INDEX MAP
 PC 11339 TR NO 44806
 SCALE: 1"=800', THOMAS 4640-D1

TRACT NO. 44806

CONTRACT NO. 11339

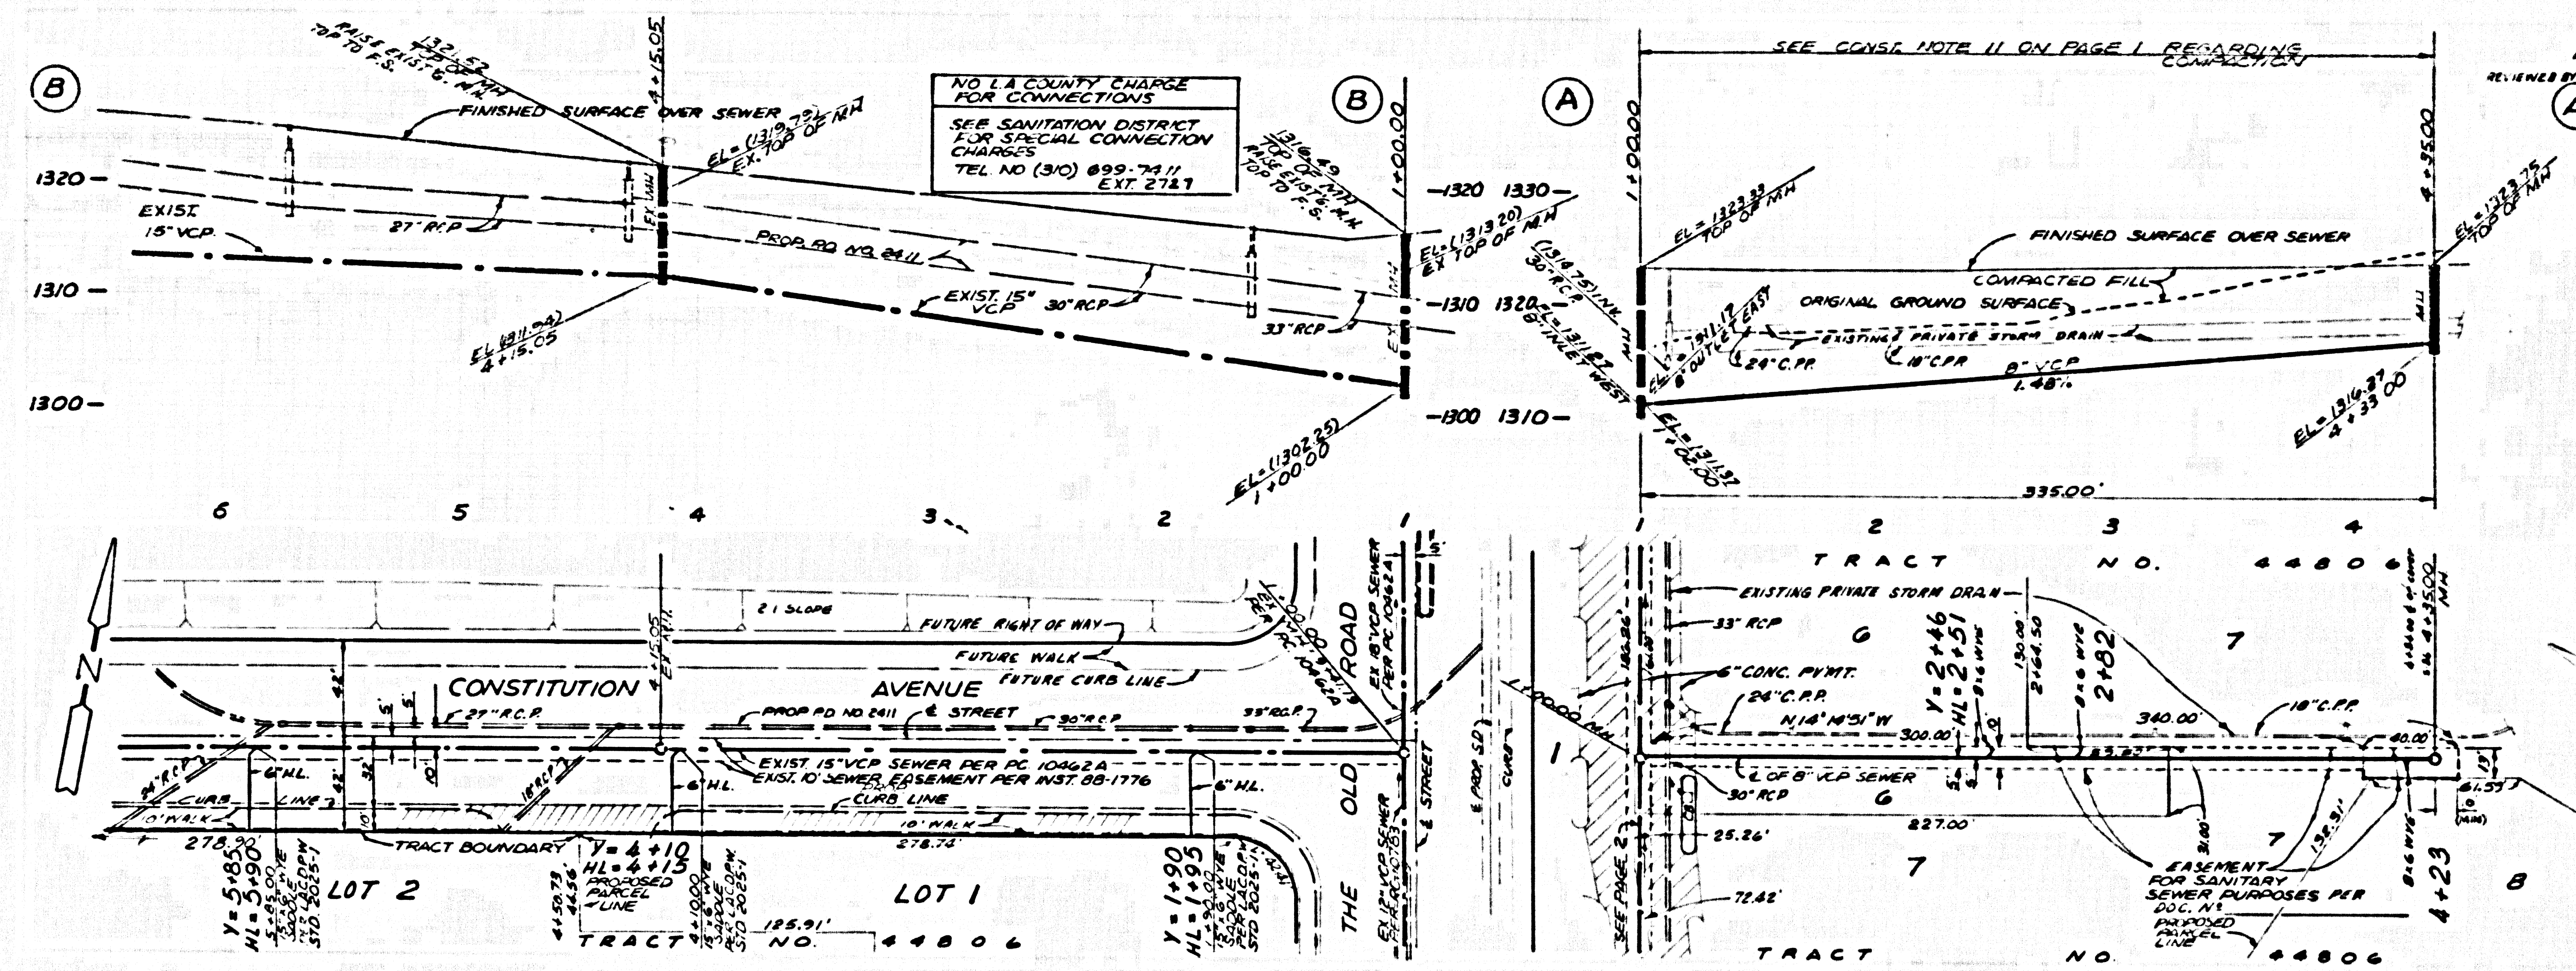
REVISION NO. 1 DATE 5/25/96
 PAGE 2 RELOCATED MH FROM STA 1+00 TO STA 0+92.26 (THE OLD ROAD) ADDED MH AT STA 1+50 REVISD STATIONS AND ELEV.
 APPROVED *Santi G. Hall*
 DEPARTMENT OF PUBLIC WORKS DATE
